CIVIL CONSTRUCTION PLANS FOR TINKER FEDERAL CREDIT UNION

LOT 3, BLOCK 1, PEAK BROKEN ARROW ADDITION

THE CITY OF BROKEN ARROW TULSA COUNTY, OKLAHOMA

COBA PROJ. NO. PT-002460-2025

1 EXTERIOR ELEVATION - EAST
1/8" = 1'-0"

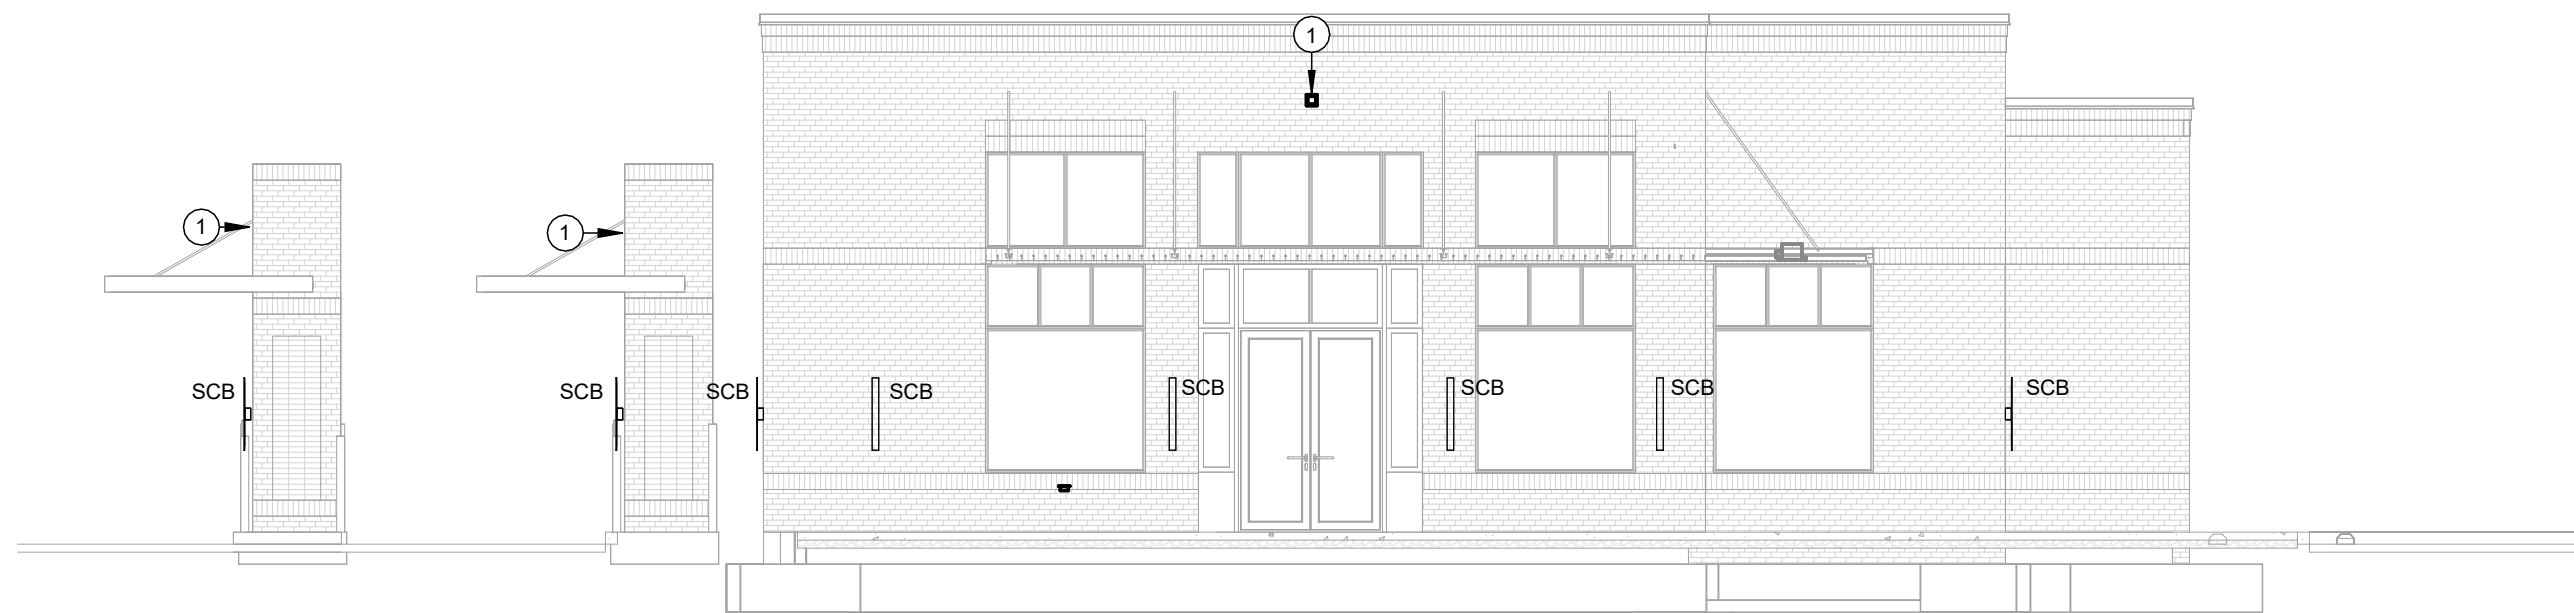
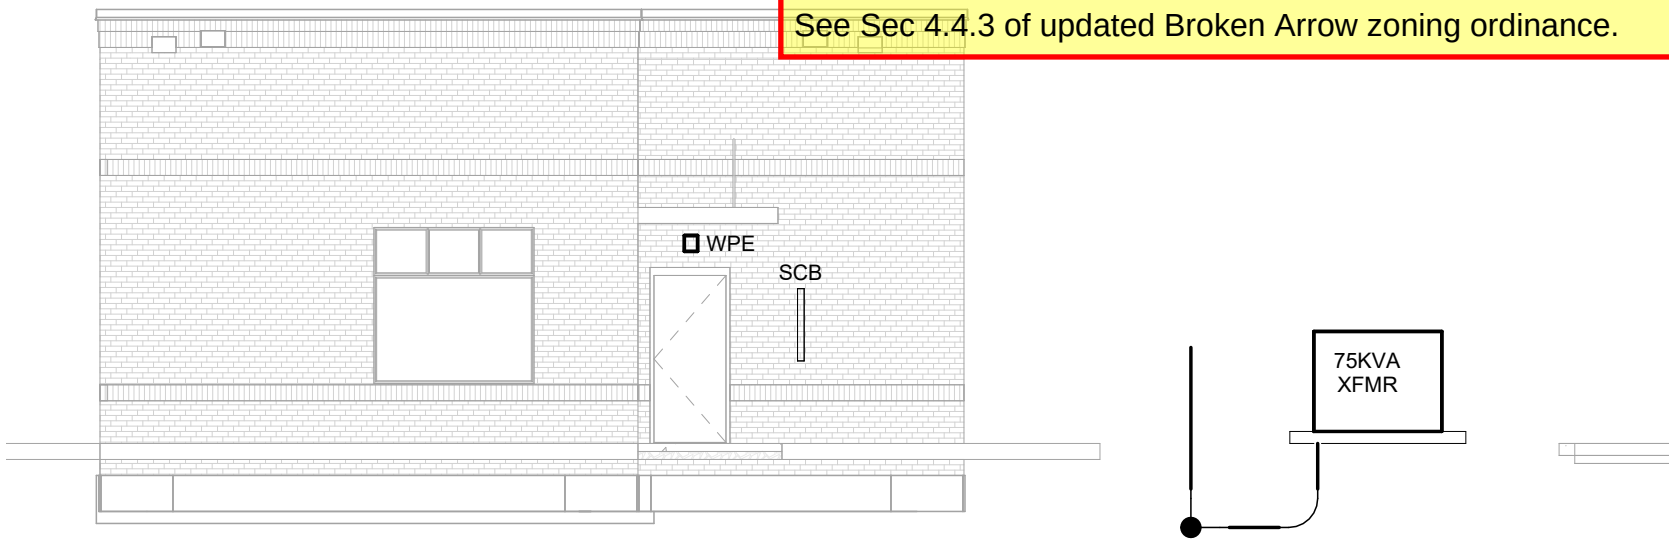
P03: Thank you for additional information. The shielding for the light fixture has to be less than 90 degrees. The following is the code:
Shielding. Light sources shall be concealed or shielded with luminaires with cut-offs with an angle not exceeding 90 degrees to minimize the potential for glare and unnecessary diffusion on adjacent property. For purposes of this standard, "cutoff angle" is defined as the angle formed by a line drawn from the direction of light rays at the light source and a line perpendicular to the ground from the light source above from which no light is emitted.

See Sec 4.4.3 of updated Broken Arrow zoning ordinance.
